From: Vince D'Alo [vdalo@aliquot.com]
Sent: Tuesday, June 19, 2012 8:19 AM
To: Ranelletti, Darin; Mog, David
Cc: drparrott@oaklandzoo.org; Roseann Dal Bello; Jason Barish; Howard Fuchs, Construction Consultant
Subject: Relocating Bio-swale to Zoo Entrance Area
Attachments: C6.02_Storm Water Control Plan-Planter Grading.pdf; C6.01_Storm Water Control Plan-Drainage Area.pdf

Attached is a 2 sheet plan of a bio-retention basin located near the Zoo entrance at the intersection of the main access with the driveway to the Educational Center. A brief history of this decision to relocate this BMP to another part of the zoo to compensate for impervious surfaces created by the Veterinarian Building is as follows.

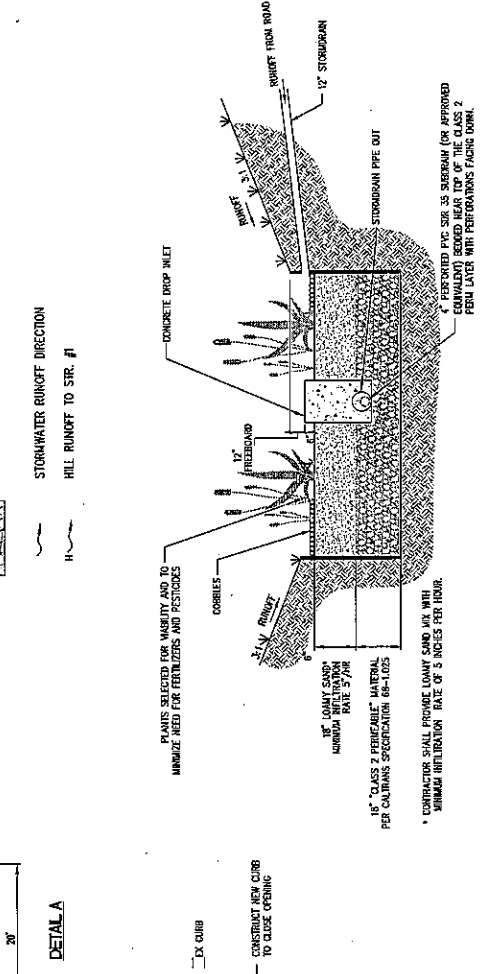
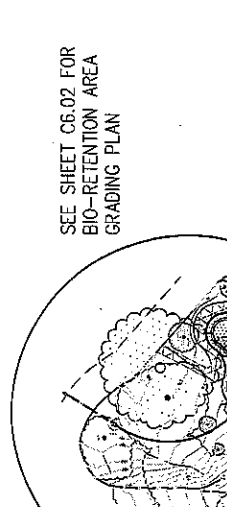
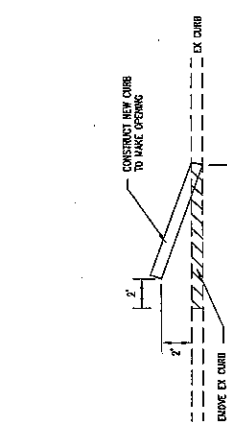
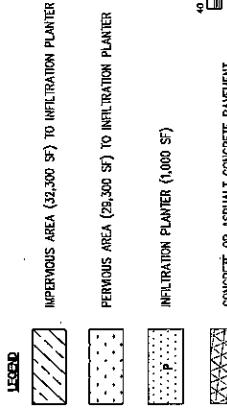
The approved bio-swale shown on Aliquot plans, located below and next to the Vet hospital, was approved by the City of Oakland. This bio-swale has not been constructed. Its planned location sets the bio-swale at the toe of a relatively steep bank along the curb of the upper parking lot. From an engineering view, creating a wet situation below the proposed pump house to California is not ideal. In addition, there are several trees on the bank, which would have been removed and are now saved. Retaining walls would have been employed to gain the surface area required of this planter-swale. Construction in this location is also problematic considering a major sub-drain located along the curb. For these reasons we proposed to move the swale. On October 24th, Roseann Dal Bello, Dr. Parrott, and myself met with you for a site review of a new location.

The proposed location of a bio-retention planter (BRP) requires the loss of several eucalyptus trees and has minimal infringement under the drip line of the 2 large oaks (see attachments). The proposed SD pipes for this BRP are positioned midway between the trunks of the oaks for minimal impact.

In addition, this new location also cleans 1200 LF of access road consisting of old A.C. pavement which ravel from use, creating fines consisting of hydrocarbons and the metals introduced by automobiles accessing the roadway. Currently, these metals and hydrocarbons are washed directly into the creek. By moving the bio-swale to this location, these road fines will flow from 1200 LF of roadway to the new BRP and will be removed, greatly reducing the source pollutants entering the creek. The source pollutants from the Veterinarian hospital are far less significant since there is no traffic in the courtyard and the roofing materials with less contaminants. Moving this BMP to the proposed location is a better use of this facility.
